780-001-11

ADDENDUM NO. 1

Freeman Public Schools
 Adams, Nebraska
 TCEP No.: 780-001-11

Addendum #01
Supplemental Drawing: SDA-007
Revision of Sheet: A6.02
Date: 09/26/12

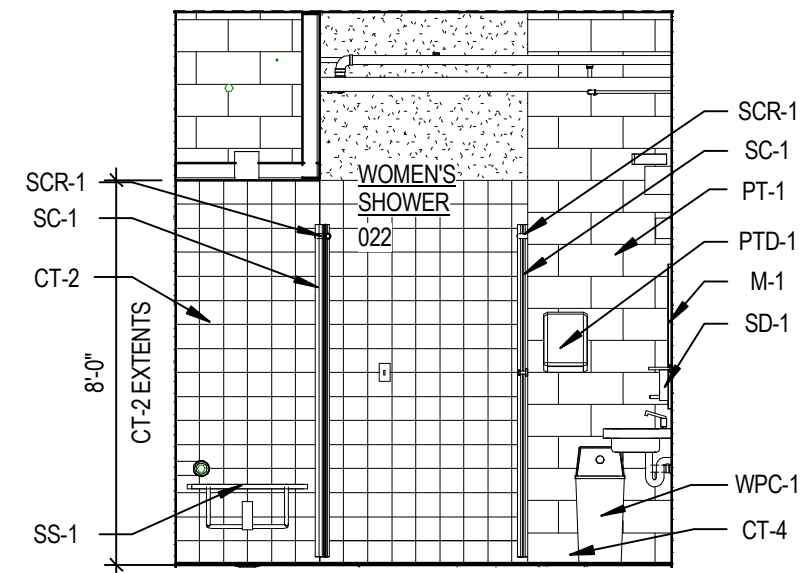
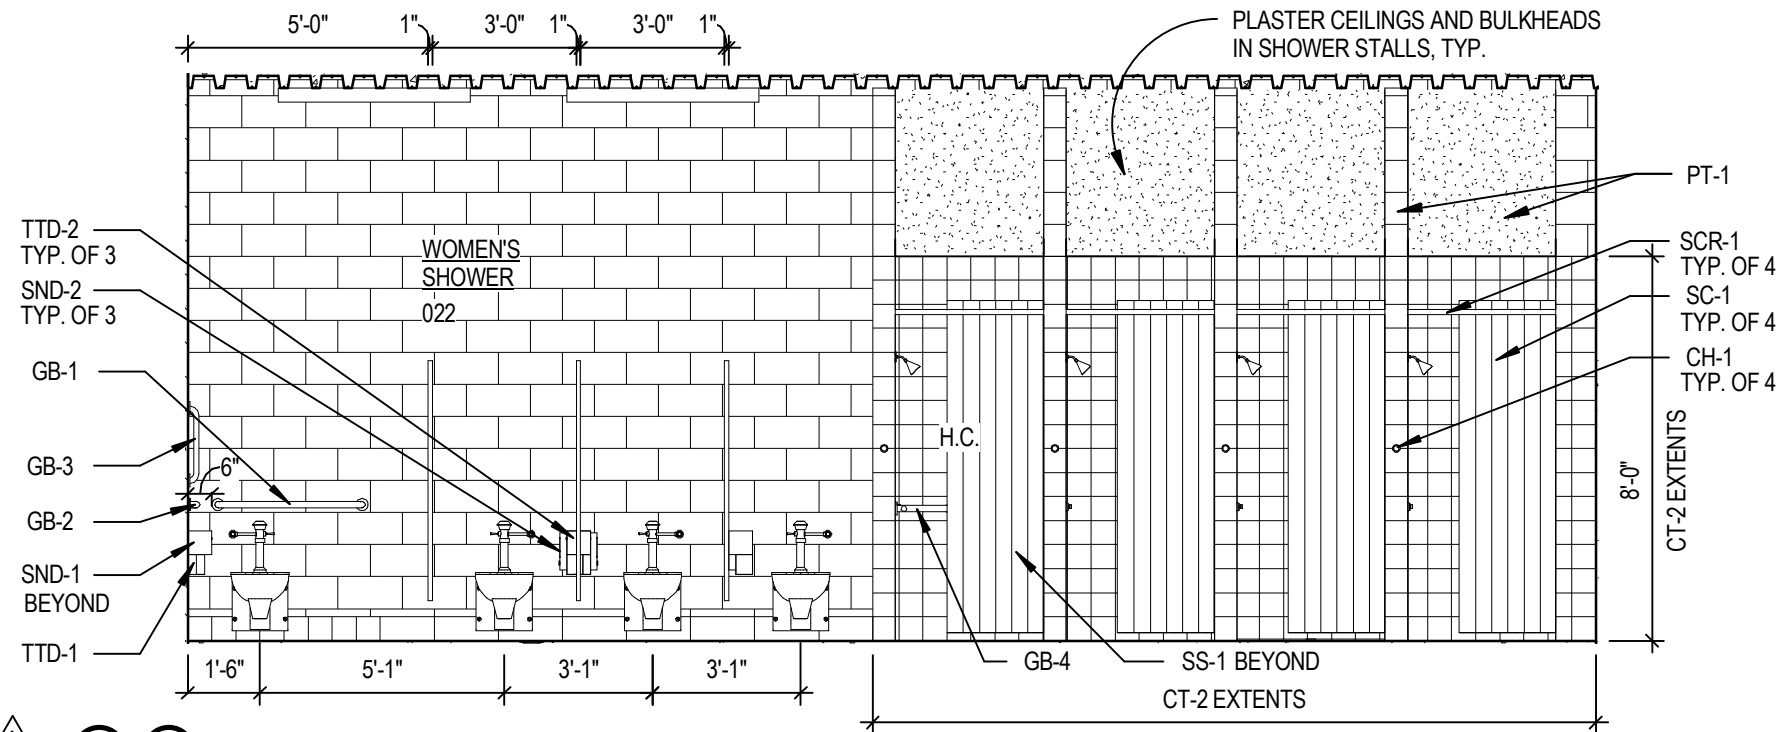
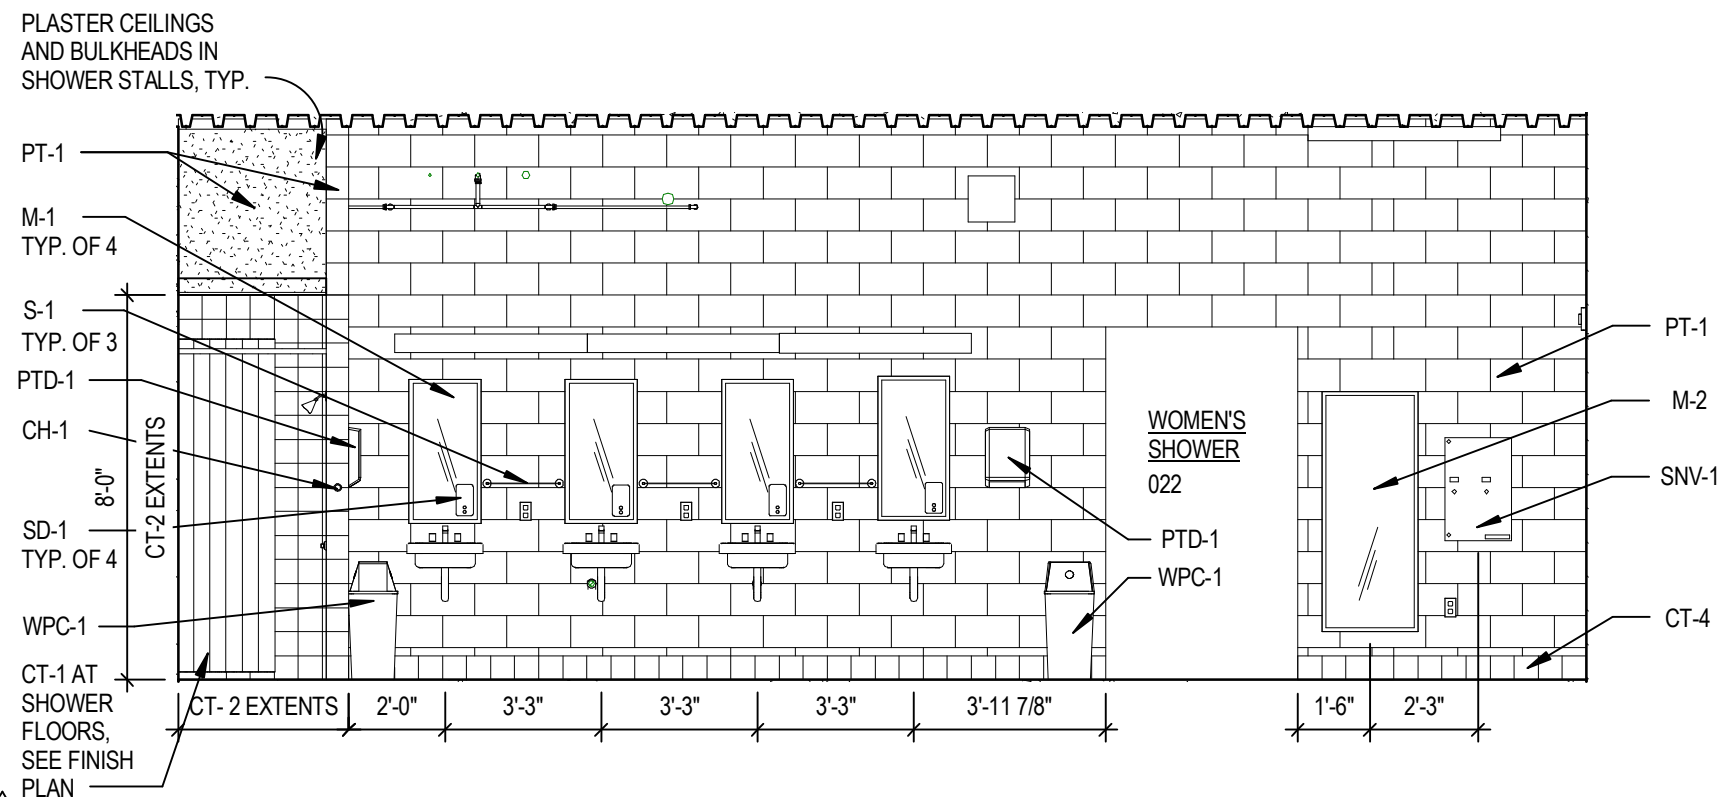
- a. Refer to attached supplemental drawing SDA-007 for changes to drawing. Changes to layout of Women's Shower 022.
- b. Refer to attached supplemental drawing SDA-008 for changes to drawing. Changes to interior elevation of Women's Shower 022. Elevation #12 - 022 – South Wall; Elevation #13 - 022 – West Wall; Elevation #14 - 022 – North Wall.

Addendum #01
Supplemental Drawing: SDF-001
Revision of Sheet: F1.00
Date: 09/26/12

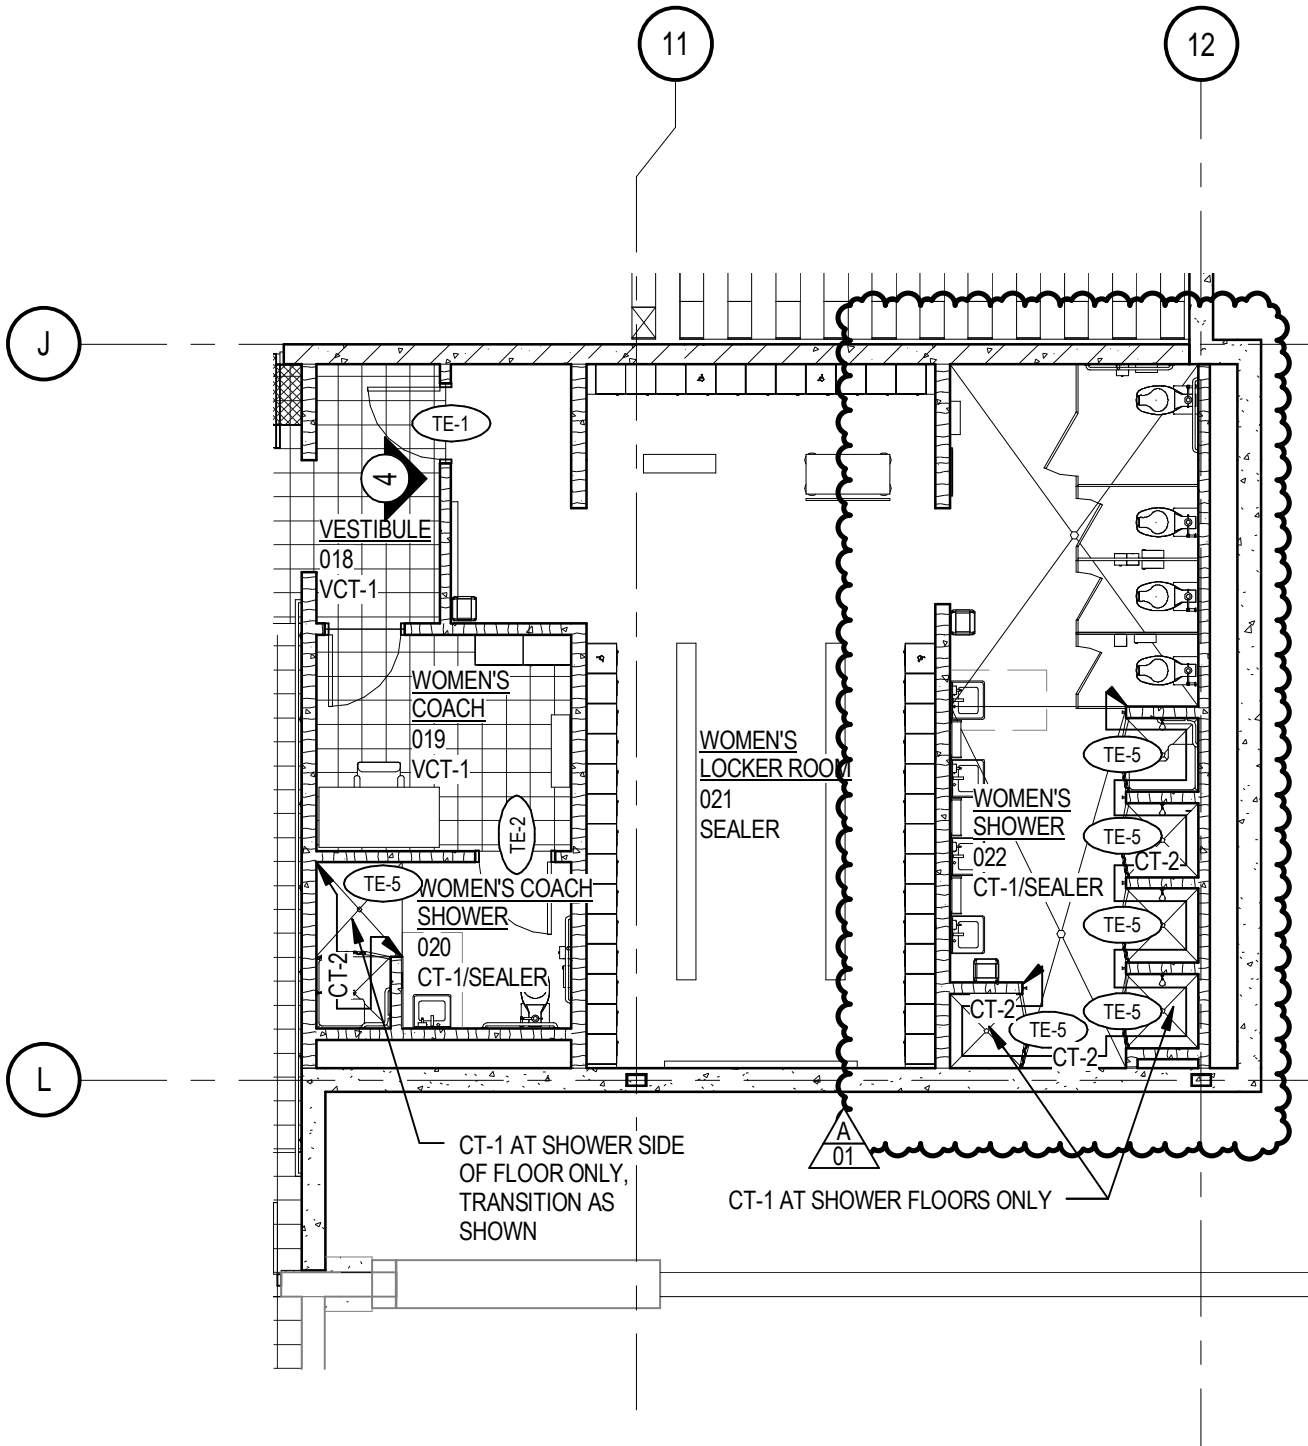
- a. Refer to attached supplemental drawing SDF-001 for changes to drawing. Changes to layout of Men's Shower 016.
- b. Refer to attached supplemental drawing SDF-002 for changes to drawing. Changes to layout of Women's Shower 022.

Addendum #01
 Supplemental Drawing: SDF-003
 Revision of Sheet: F1.10
 Date: 09/26/12

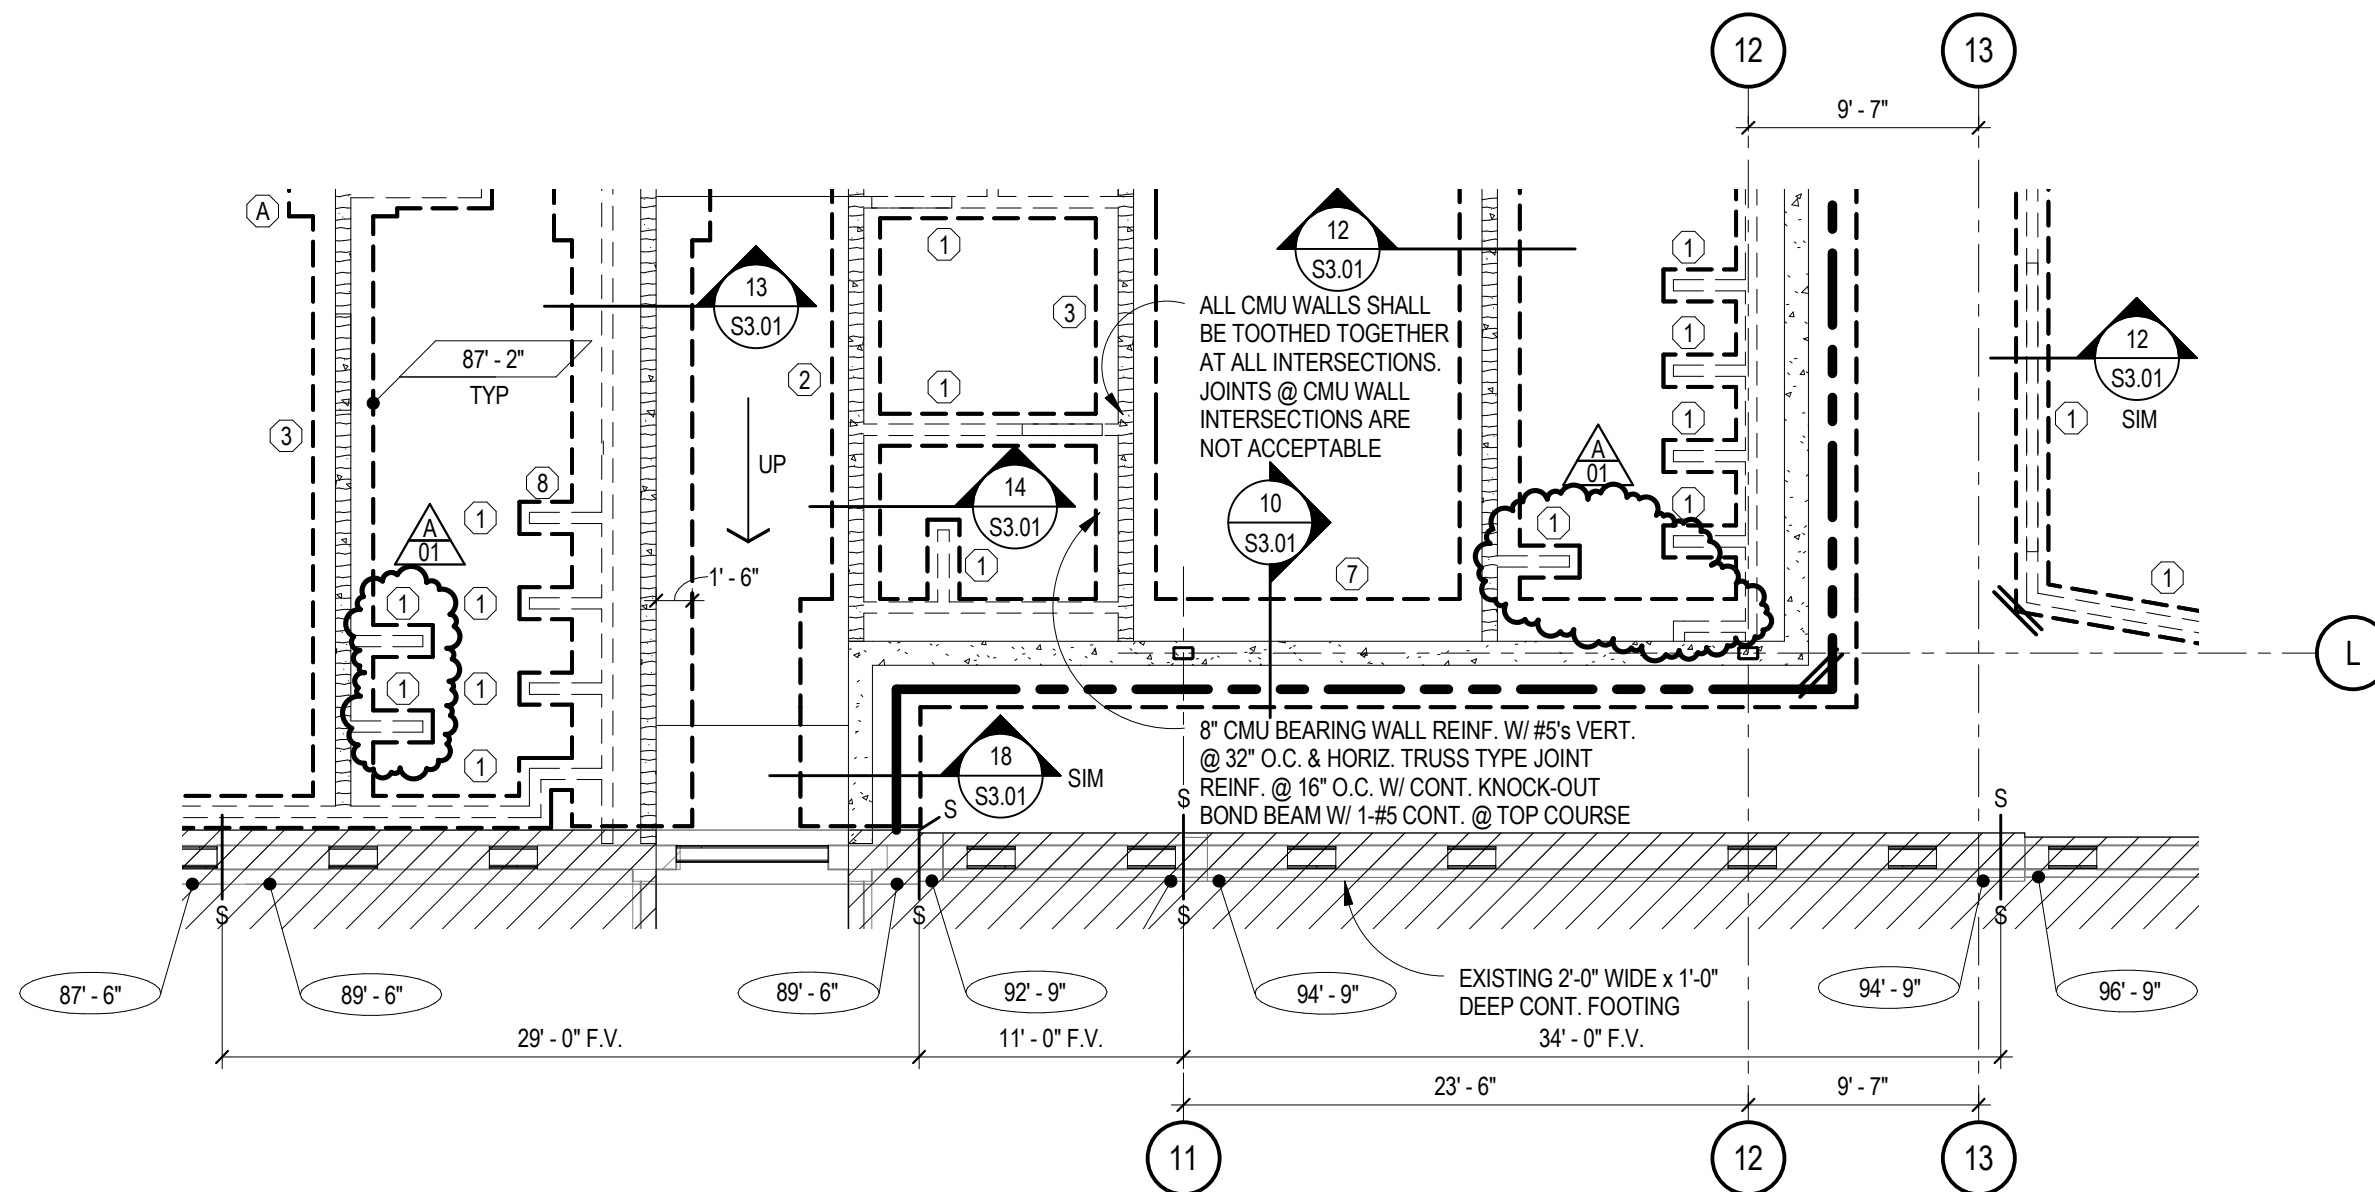
- a. Refer to Finish Schedule. Change wall finish in Men's Shower 016 on North wall to PT-1/CT-2 reflecting changes shown on SDF-001 (revised showers layout).
- b. Refer to Finish Schedule. Change wall finish in Women's Shower 022 on North wall to PT-1/CT-2 reflecting changes shown on SDF-002 (revised showers layout).
- c. Refer to attached supplemental drawing SDF-003 for changes to drawing. Changes to transition edge TE-5 (CT to Concrete/VCT).

Addendum #01
Supplemental Drawing: SDS-001
Revision of Sheet: S1.01
Date: 09/26/12

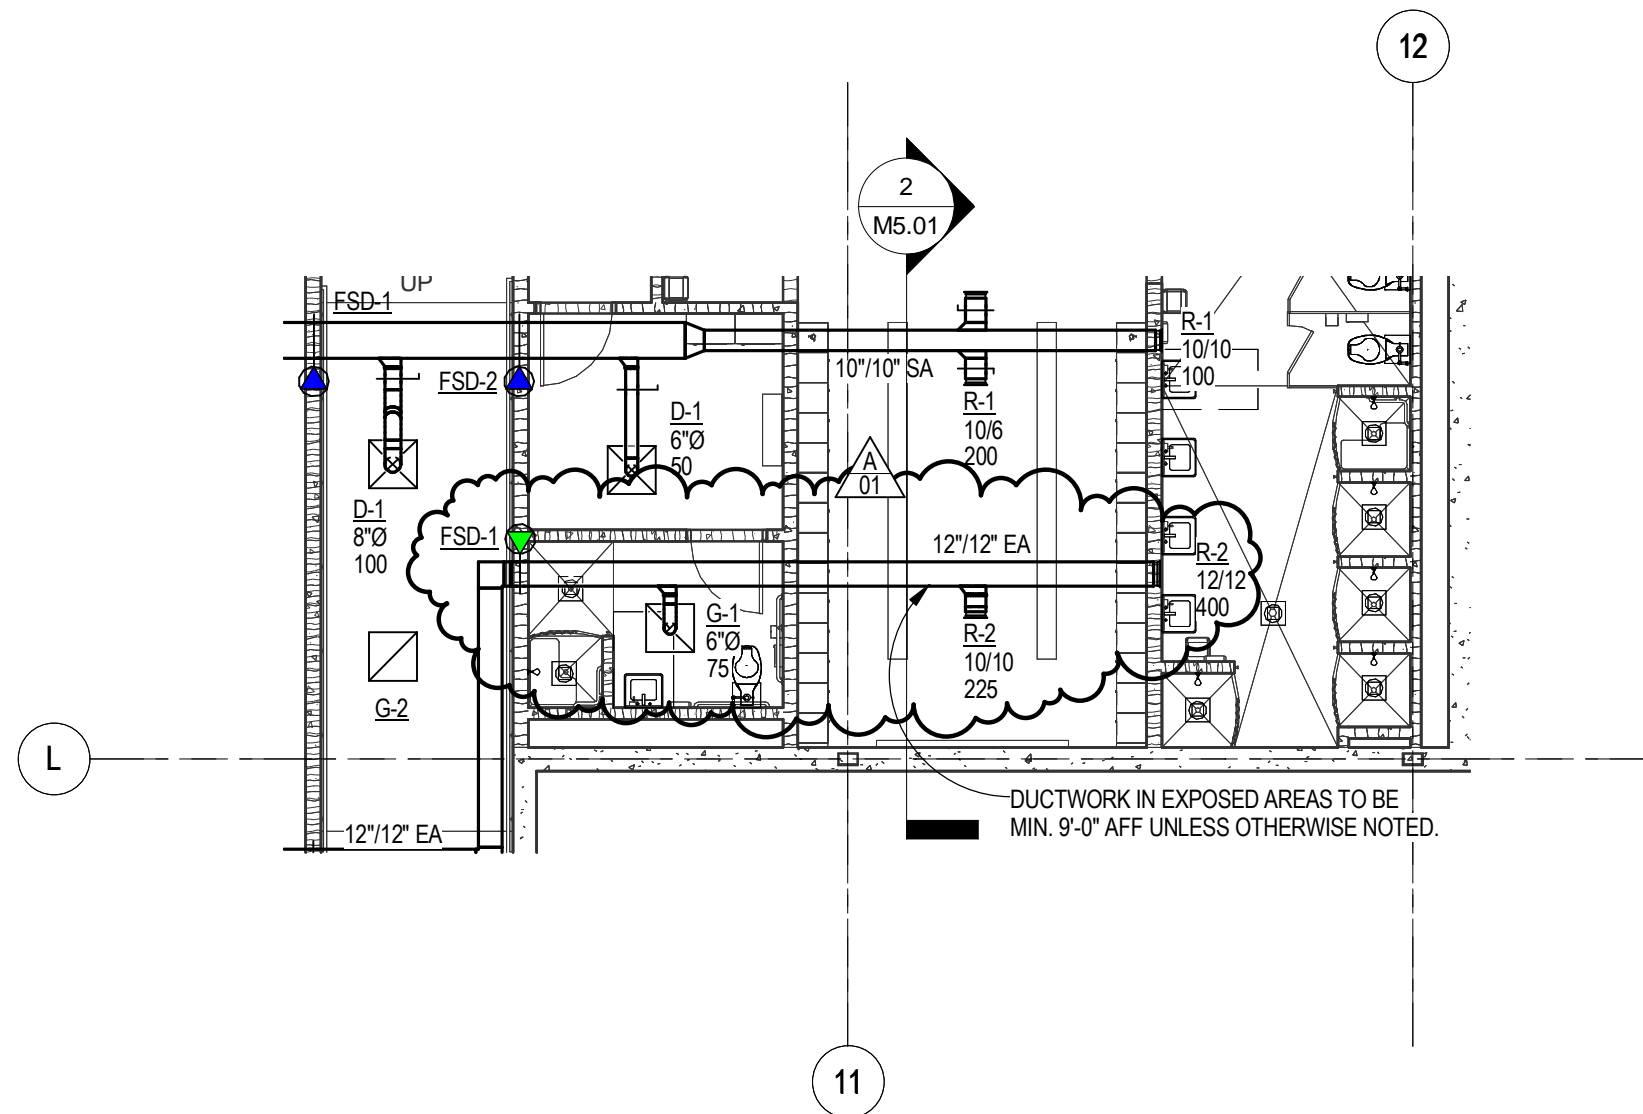
Refer to attached supplemental drawing SDS-001 for additional footings at showers.
